CNRO-2003-00048

SUBJECT: Entergy Operations, Inc.
Response to Requests for Additional Information Pertaining to Relaxation Requests to NRC Order EA-03-009 for In-Core Instrumentation Nozzles

Arkansas Nuclear One, Unit 2
Docket No. 50-368
License No. NPF-6

Figure 1a: Axisymmetric Counterbore Nozzle FEA model for Internal pressure

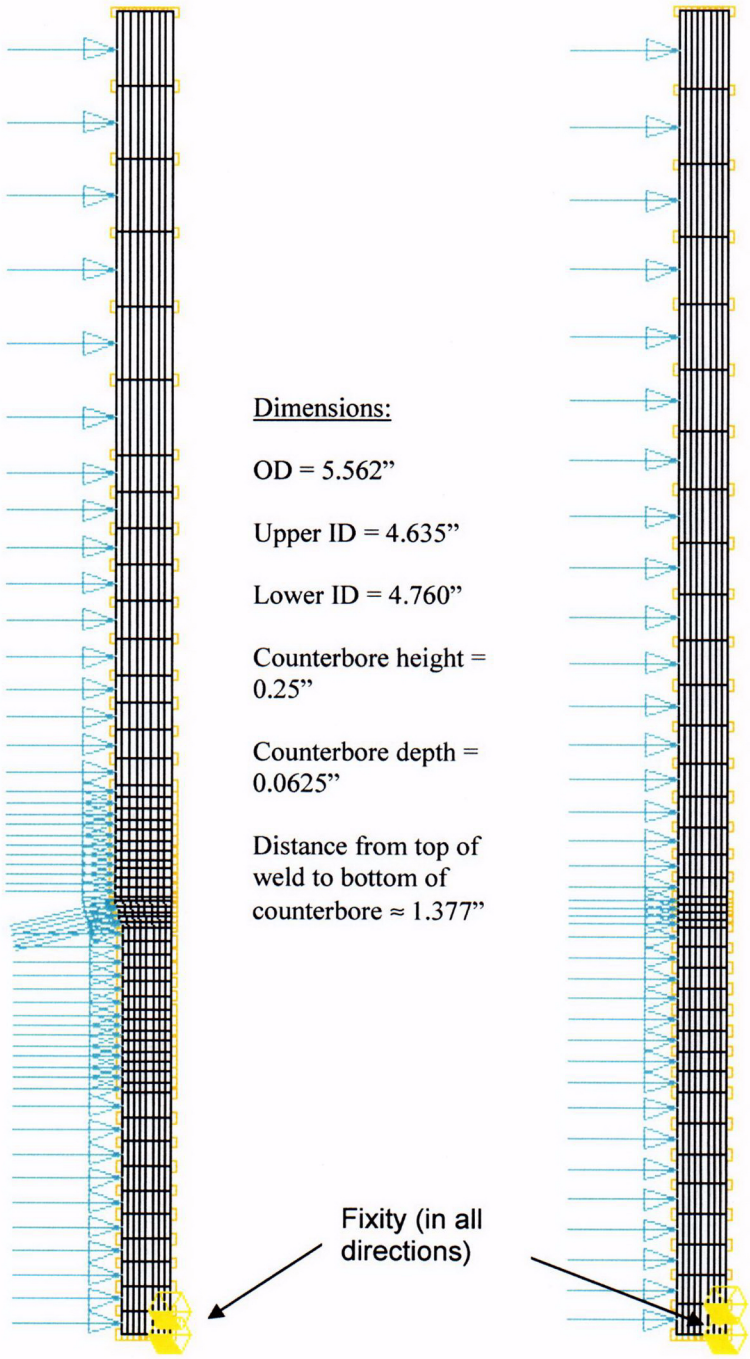
It is stated in Section 3.1 of Enclosure 2 of your September 3, 2003 application [Entergy letter CNRO-2003-00035] that the counterbore was not explicitly modeled. This modeling is acceptable if the propagating crack tip is at some distance from the highly stressed area caused by the counterbore. However, for crack tips located within this highly stressed area such as Case 4 of your fracture mechanics analysis, you may need to evaluate the impact of the stress concentration factor (e.g., from Peterson's handbook) caused by the counterbore on the applied K calculation.

To address the explicit effect of a counterbore on the inside diameter (ID) of a cylinder (such as the ICI nozzle), several simplified finite element analysis (FEA) models were performed to quantify the relative impact of the counterbore on the applied stresses on the ICI nozzle. These stresses are used in the deterministic fracture mechanics evaluation of an axial surface flaw in the counterbore region. Two nozzle configuration models were evaluated:

Both cylinders had an outside diameter (OD) of 5.562 inch. The IDs of the counterbore models were 4.635 inches above the counterbore, and 4.760 inches below the counterbore; the straight cylinder model included a 4.760-inch ID. The counterbore was modeled 0.25 inch in length and 0.0625 inch in depth per ANO-2 design drawings

The flaw in the 0.88-inch blind zone is subject to membrane and bending residual + operating loads. To simulate the applied hoop loading conditions for which the axial flaw would be subject to and propagate in, two models for each nozzle configuration were constructed. The first set of models consisted of a unit (1000 psi) internal pressure load to simulate the contribution of the applied pressure loading in the nozzle and fixity applied on the OD at the bottom of the nozzle to simulate weld or head restraint. Figures 1a and 1b below show the two internal pressure models. The second set of models consisted of a horizontal unit force (1000 lb. or 1 kip) applied to the OD of the nozzle, with the top of the nozzle (away from the region of load application) fixed, to simulate the "hoop bending" effect caused by the J-groove weld residual stresses. This load condition will cause nozzle ovality, which is the primary cause of the hoop membrane and bending stresses in the nozzle. Figures 4a and 4b show the hoop bending load models.

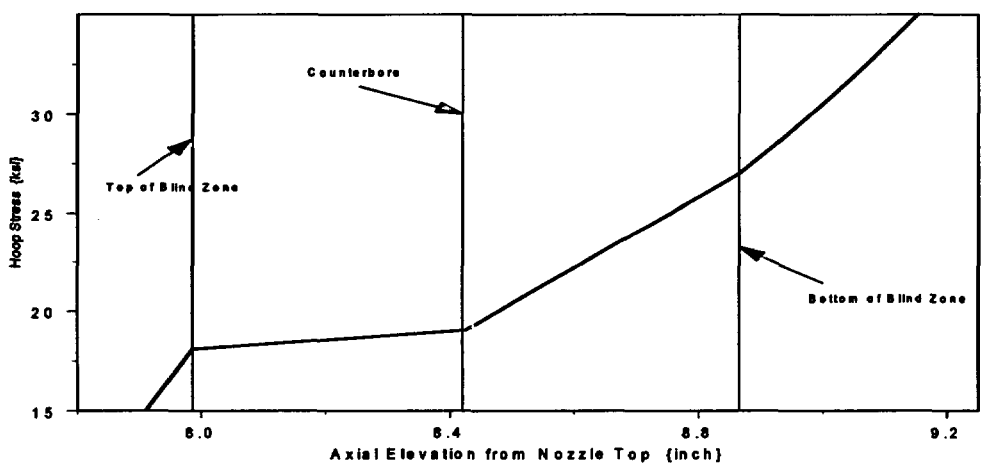
The applied K calculation for inside diameter (ID) surface flaws employed the "moving average scheme," which was also used in the fracture mechanics analyses for ID and outside diameter (OD) surface flaws for control element drive mechanism (CEDM) nozzles. An error analysis of this scheme is not necessary in the CEDM nozzles application because the results for the corresponding through-wall flaws are limiting with only one exception, and this exception is due to your approach of assuming the upper crack front for an initial OD or ID flaw to be 0.16 inch ahead of a corresponding through-wall flaw. In the in-core instrumentation (ICI) application, since the ID surface flaw is the only concern, a quantitative error analysis is required. One way to estimate the error is to find the ratio between the applied K for a crack with a concentrated opening force acting close to the crack tip and that for a crack with your average opening stresses. The concentrated force represents the difference between the stresses in the moving segments and the average stress.

The evaluation to determine the error by using the moving average stress for determining the stress intensity factor (SIF) followed the guidance provided in the NRC's question. The stress distribution considered for this evaluation was the ID surface stress in the counterbore region. The finite element analysis (FEA) nodal hoop stresses for the ID surface were fit with a third order polynomial. The curve representing the stress distribution is shown in Figure 1. In this figure the top and bottom of the blind zone together with the location of the counterbore are provided. The postulated crack encompasses the entire blind zone and is 0.88 inch long.

The stresses used to calculate the force used in the wedge crack model were from the stress distribution shown in Figure 1, whereas the stresses used for the CCP model were the moving average stresses obtained using the formulation described in Engineering Report M-EP-2003-003 (Enclosure 2 of Entergy letter CNRO-2003-00035). It is recognized that since the assumed crack encompasses the entire blind zone, the crack tip at the top of the blind zone is at a considerably lower stress. Hence, the average stress applied to the crack would be lower than the stress prevailing at the crack tip located close to the bottom of the blind zone. The wedge force was applied at the location of the initial crack tip (for the first iteration) and the half crack length was 0.458 inch. The wedge force model would provide the incremental SIF produced by the higher stresses at the crack tip at the bottom of the blind zone. The applied stress used for the CCP model was the average stress described above. Thus, the sum of the SIF from the two models would provide the prevailing SIF at the crack tip closest to the bottom of the blind zone. A ratio of the total SIF divided by the SIF obtained from the CCP model would provide the estimated error in the determination of the SIF using the model used in Engineering Report M-EP-2003-003.
